DART AEROSPACE LTD		Work Order: 59073
Description: Floor Protector, Fwd LH		Part Number: D3281-1
Inspection Dwg: D3281	Rev: DE BL.	Page 1 of 1

DRAWING NO. D3281	TITLE FLOOR PROTECTOR	REV. E	DART AEROSPACE LTD ENGINEERING ORDER		D.E.O. NO. D3281-E-1	SHEET NO. SHEET 1 OF 1	SCALE NTS
DRAWN <i>q</i>	CHECKED <i>K</i>	MFG. APPR. <i>JK</i>	APPROVED <i>JK</i>		DE APPR. <i>JK</i>		
DATE 10.02.24	DATE 10.02.25	DATE 10/02/25	DATE 10.02.25		DATE 10.02.25

PURPOSE

ADD "D3281-xL08" MATERIAL OPTION. EXISTING PARTS TO BE IDENTIFIED AS "D3281-xL02"

D3281-1L08 FLOOR PROTECTOR (SHOWN)
D3281-2L08 FLOOR PRETECTOR (OPPOSITE)
 LOCATION OF ENGRAVING

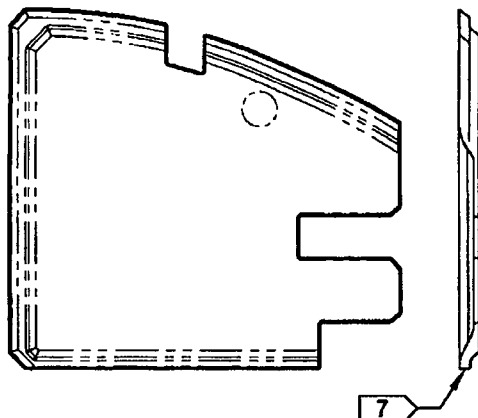
D3281-xL08 PARTS ARE EQUIVALENT TO THE RESPECTIVE "-x" PARTS EXCEPT AS DETAIL BELOW. THE MATERIAL, IDENTIFICATION, AND WEIGHT NOTES ARE AMENDED AS FOLLOWS:

- 2) MATERIAL: -xL02 = LEXAN F6006, BLACK No. 701, 0.093" THICK (MLEXS.093-F6006-02)
 -xL08 = LEXAN 90318 (PROTECT-A-GLAZE), 0.118 THICK, 112-CLEAR (MLEXS.118-90318-08)

- 7) IDENTIFICATION: IDENTIFY WITH DART P/N "D3281-xLxx" AND B/N "Bxxxxx" ON SMOOTH SIDE OF PART USING VIBRATING STYLUS.
 FOR -xL08 PARTS, LOCATE ENGRAVING ALONG PERIMETER OF PART AS SHOWN.

- 8) WEIGHT: D3281-1L02/-2L02 = 0.95 lb D3281-1L08/-2L08 = 1.13 lb
 D3281-1L02/-2L02 = 0.87 lb D3281-3L08/-4L08 = 1.05 lb
